# DEVELOPMENT REVIEW COMMITTEE (DRC) COMMENT REPORT

**PROJECT NAME:** Holden Ft. Lauderdale – Senior Living

**CASE NUMBER:** PLN-SITE-20020003

**REQUEST:** Site Plan Level III Review: Conditional Use - Social Service Residential Facility (SSRF) with 211 Assisted Living Units and 25 Memory Care Units, Waterway Use and associated Parking Reduction

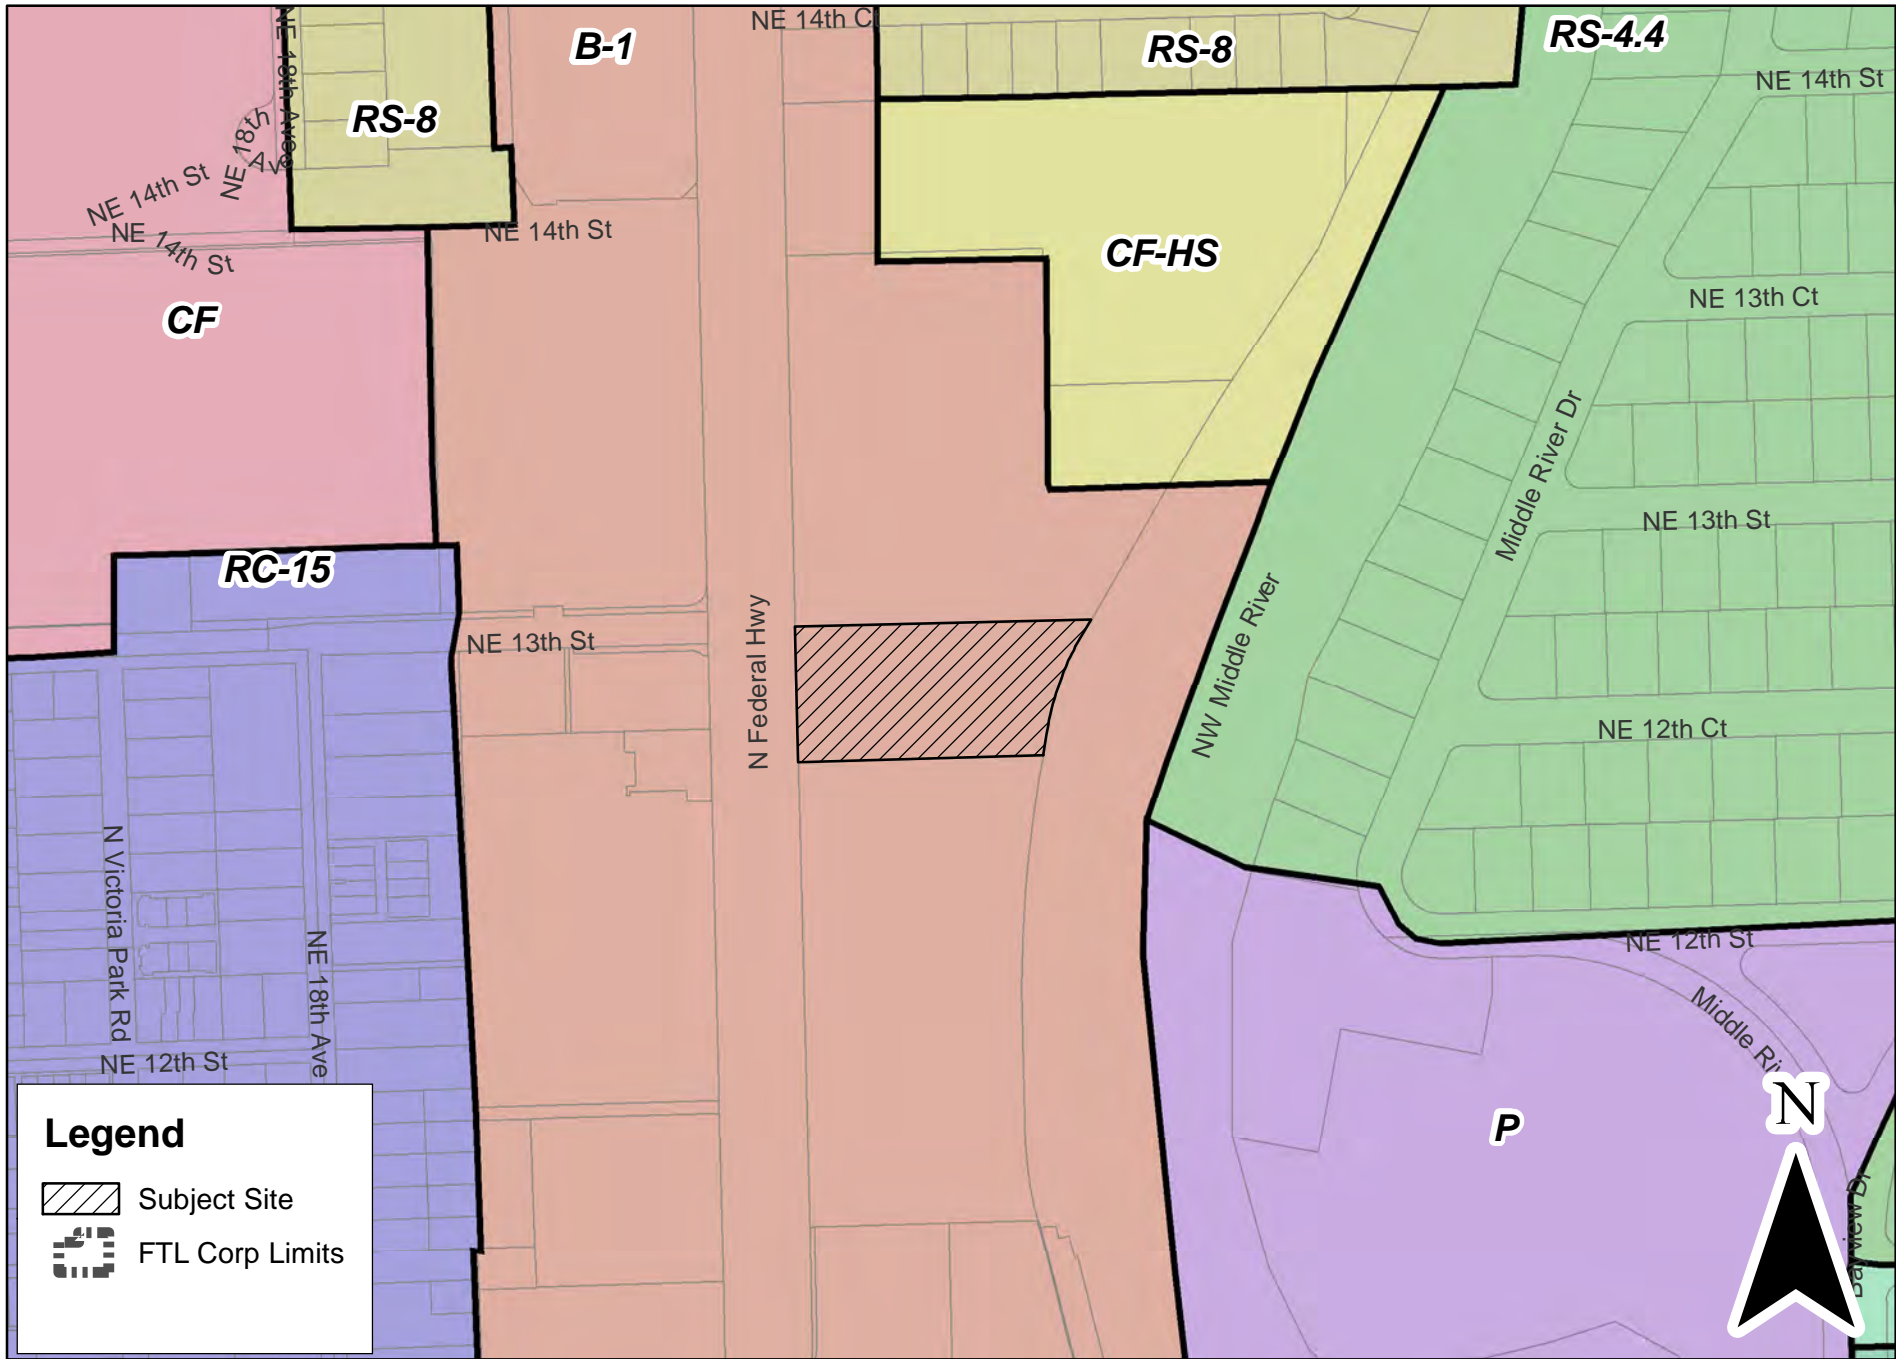
- f. Provide elevations from the waterway at ground/water level and renderings of such. More detailed elevations and renderings may be needed.
14. Pursuant to ULDR, Section 47-23.9, Interdistrict corridor requirements, applications for development subject to interdistrict corridor requirements shall demonstrate that the project provides a spatial framework supportive of a pedestrian and multi-modal transportation environment along Federal Highway. Such framework shall encourage the direct pedestrian access from sidewalk to development

and contain elements such as seating areas, shade structures, plaza elements, and open space. Given the frontage of the property contains an FPL easement, certain elements stated above may not be permitted. Provide documentation from FPL granting approval for proposed site design.
